Beaver Valley Power Station, Unit No. 2  
Docket No. 50-412, License No. NPF-73

Response to Request for Additional Information for License Amendment Request  
No. 08-027, Unit 2 Spent Fuel Pool Rerack (TAC No. ME1079)

ATTACHMENT 1  
L-10-235

Response to May 27, 2010 NRC Request for Supplemental Information  
Page 1 of 20

Figure 1 – LS-DYNA Model for Cell Wall Buckling Evaluation

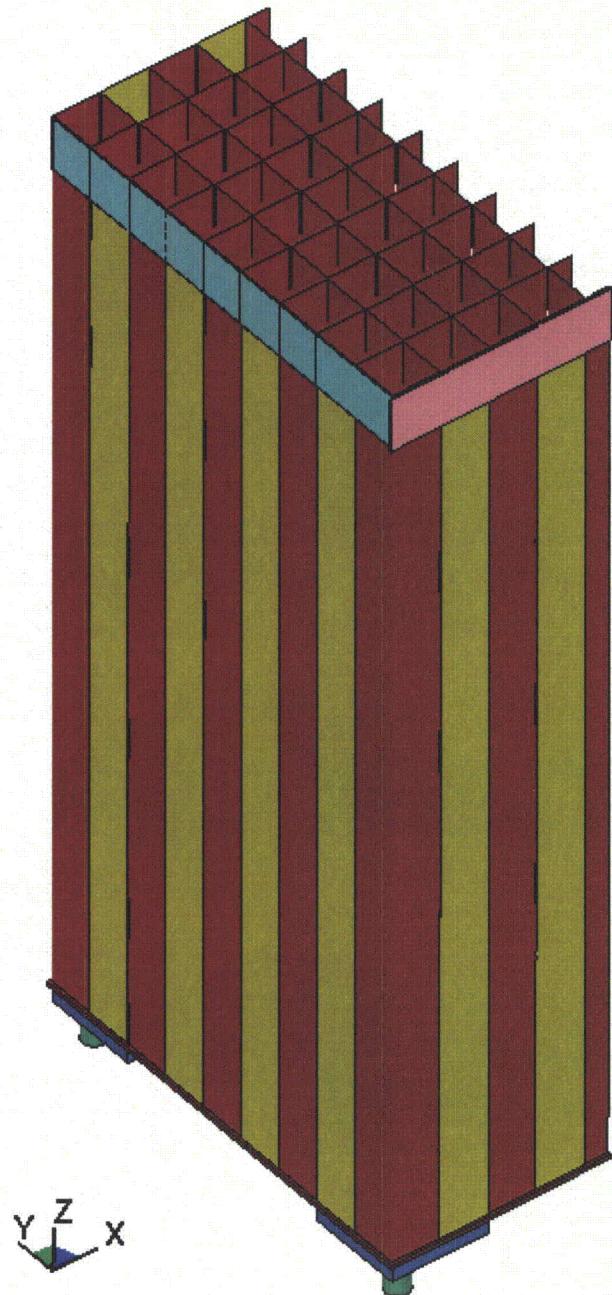
**Supplement to RAI 2:**

The buckling potential of the cell walls at the top of the rack, which are subject to lateral impact loads, are investigated using the computer code LS-DYNA as described in the response to RAI 11.c in Reference 2. The response to RAI 2.a in Reference 3 incorrectly identified the computer code as ANSYS. This is incorrect since LS-DYNA was the computer code used. LS-DYNA is used, as opposed to a classical plate buckling solution, due to the complex nature of the loading and the boundary conditions. Figure 1 below shows the LS-DYNA model used for this buckling evaluation.

The  $\frac{1}{2}$ -symmetric model includes all major components of the rack, namely the cell walls, the base plate, the support pedestals, and the reinforcement bars. The model also includes a 10 inch deep by 41.5 inch wide rigid plate (shown in pink in Figure 1), which represents the reinforcement bar on the adjacent rack involved in the impact (referred to hereinafter as rigid impactor). The rack-to-rack impact is simulated in LS-DYNA by applying a pressure time-history on the +y face of the rigid impactor, which is constrained to move only in the y-direction. The peak magnitude of the pressure time-history is arbitrarily set equal to twice the maximum rack-to-rack impact force predicted by DYNARACK under SSE conditions. The duration of the pressure pulse is equal to the duration of the maximum rack-to-rack impact from the DYNARACK simulation. The side of the rack opposite the rigid impactor is fixed against translation.

Figure 17-1: True Stress Strain Curves  
(a) Weld; (b) Base Material

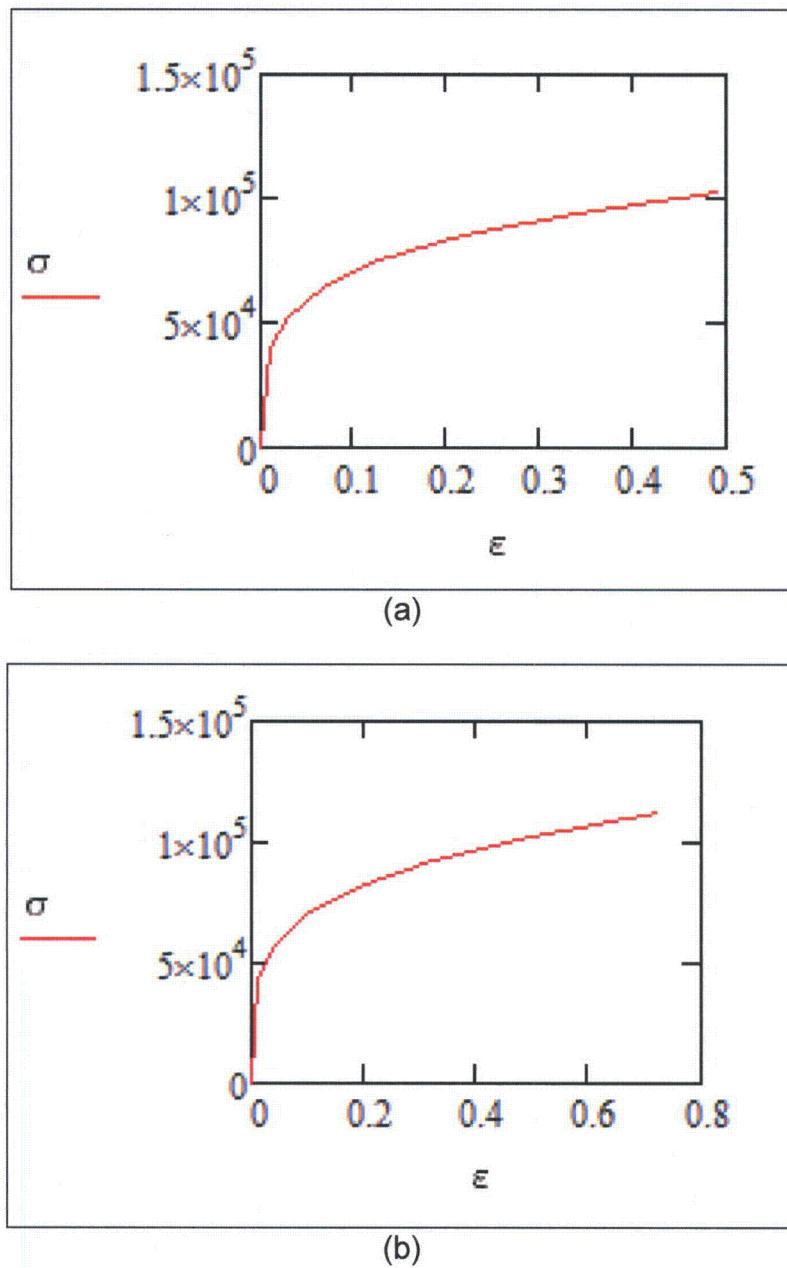
**Supplement to RAI 17:**

To address the staff's comments/concerns, the shallow fuel drop accident has been re-analyzed using LS-DYNA to incorporate the following changes:

- 1) the stress-strain curve for the weld material is switched from a bi-linear, engineering stress-strain curve to a power law, true stress-strain curve;
- 2) the uni-axial failure strain limits for the base metal (SA-240 304L) and the weld material (Type 308) are the 98 percent exceedance probability failure strain values based on the data provided in Table B.1 of NUREG-1864 (Reference 12);
- 3) a lower bound triaxiality factor is applied to the uni-axial failure strain limits at the start of the simulation;
- 4) a strain rate amplification curve developed from the test data in Reference 13 is applied to both the base metal and the weld material.

Figure 17-1 shows the stress-strain curves for the base metal and the weld material that are input to LS-DYNA for the shallow fuel drop accident analysis. As shown in the figure, the uni-axial failure strain limits for the base metal and the weld material are 0.724 and 0.493, respectively. The uni-axial failure strain limits are calculated according the following relationship:

Figure 19-1: Rack Drop Impact Force Time History

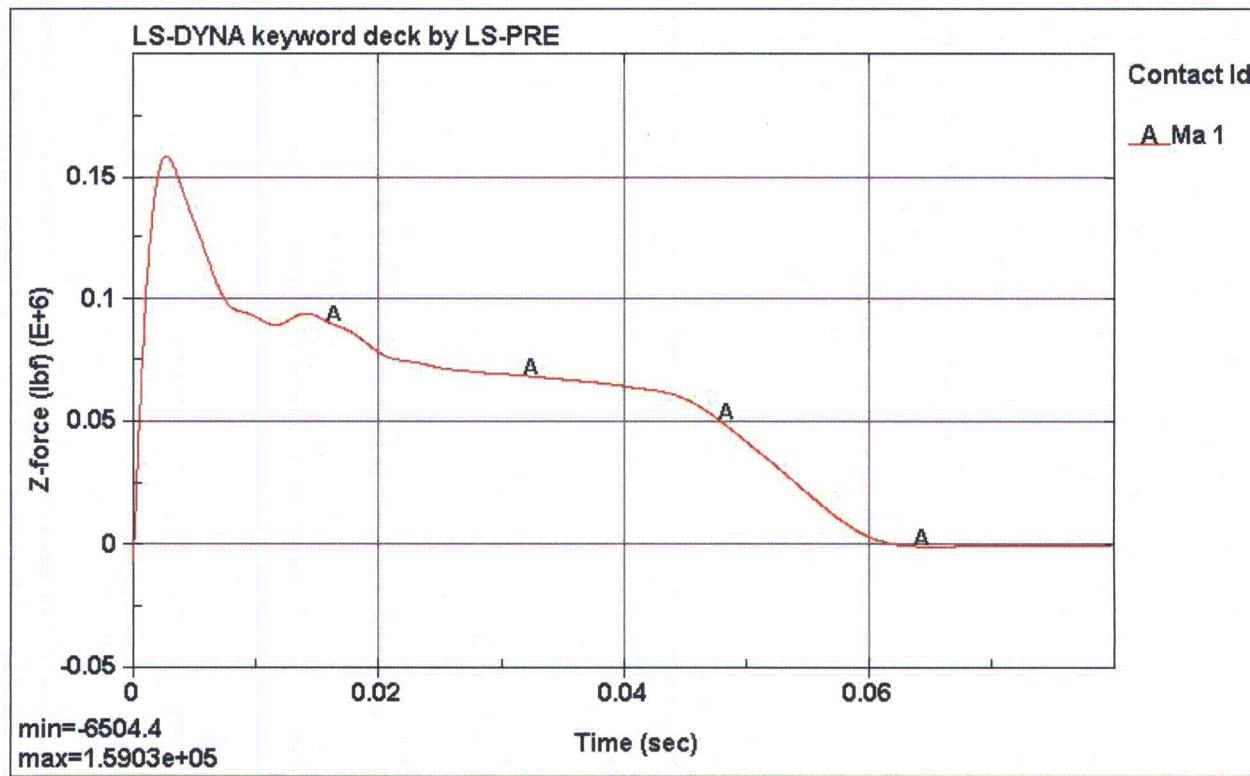
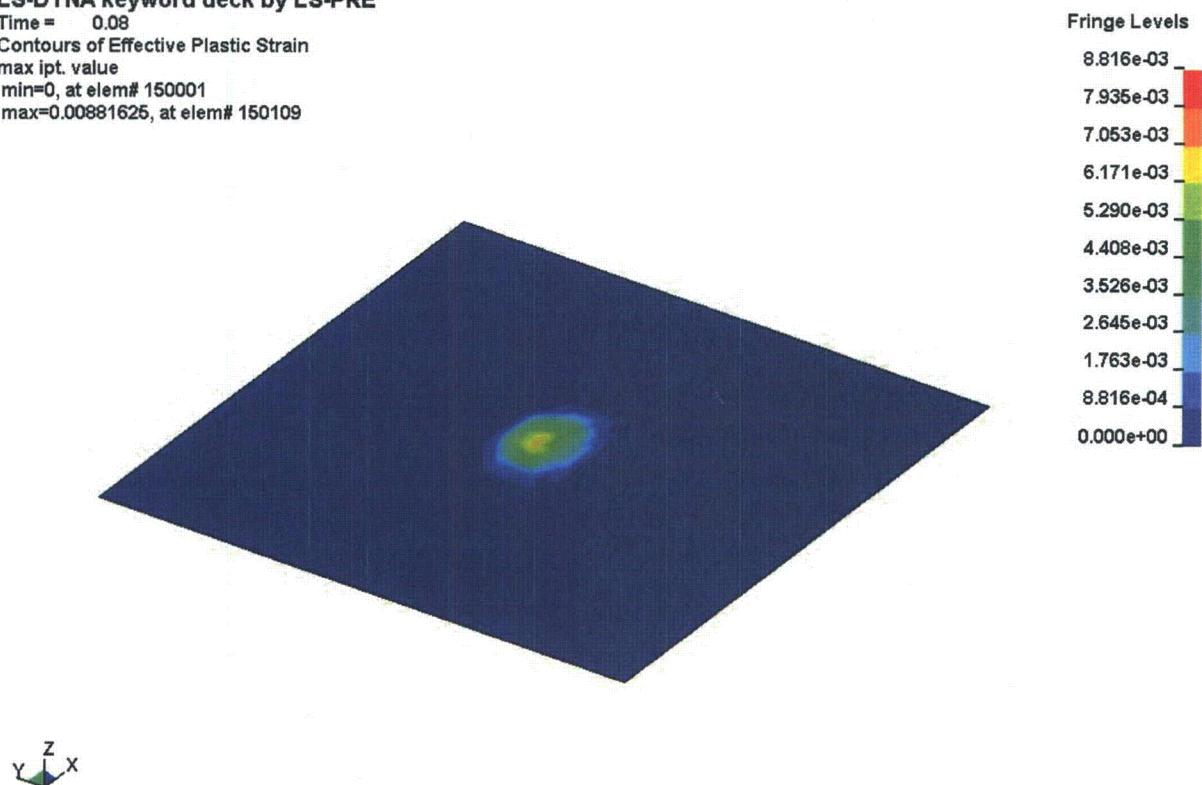
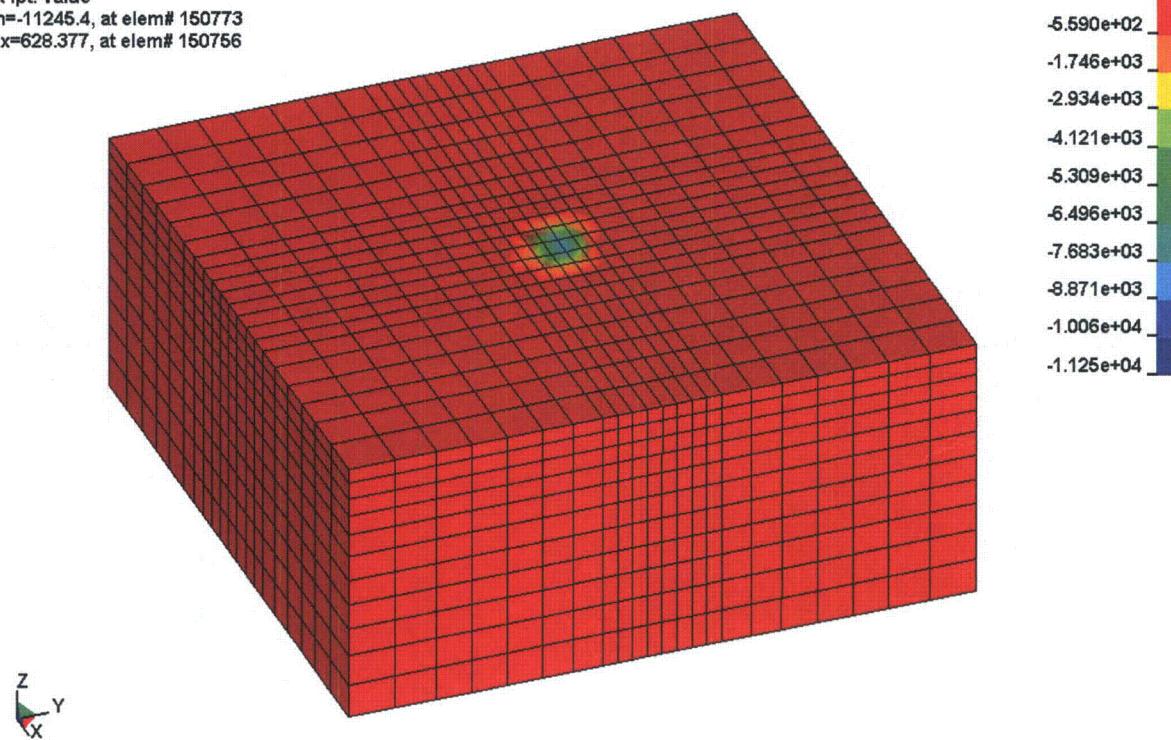
**Supplement to RAI 19:**

The 4,000 psi concrete compressive strength was used as input only for the rack drop analysis performed in previous revisions of Reference 14. The structural evaluation of the reinforced concrete SFP at BVPS Unit No. 2, under the increased loads from the spent fuel racks, uses the design basis minimum concrete strength of 3,000 psi (Reference 6).

The rack drop analysis has been re-performed using the design basis minimum strength of 3,000 psi. Apart from the change in concrete strength, no other changes to the LS-DYNA simulation model have been made. The results of the re-analysis are summarized below.

The rack drop accident analysis results for 3,000 psi concrete are shown in Figures 19-1 to 19-3 and summarized in the table below. The maximum plastic strain of the SFP floor liner is well below the failure strain of 0.4 for the liner material, indicating that there is no loss of water after the rack drop event. Nevertheless, the SFP floor slab will experience limited local damage as shown in Figure 19-3 due to excessive compressive stress resulting from the impact load at the pedestal/liner interface. In addition, the dropped rack also experiences local plastic deformation in the cells adjacent to the pedestal.

<b>Rack Drop Analysis Results Based on 3,000 psi Concrete</b>	
Impact Duration (seconds)	0.62
Peak Impact Force on the SFP Floor (pounds-force)	$1.59 \times 10^5$
Maximum Plastic Strain of the SFP Liner	$8.82 \times 10^{-3}$
Number of Plastically Deformed Cells Near Pedestal	8
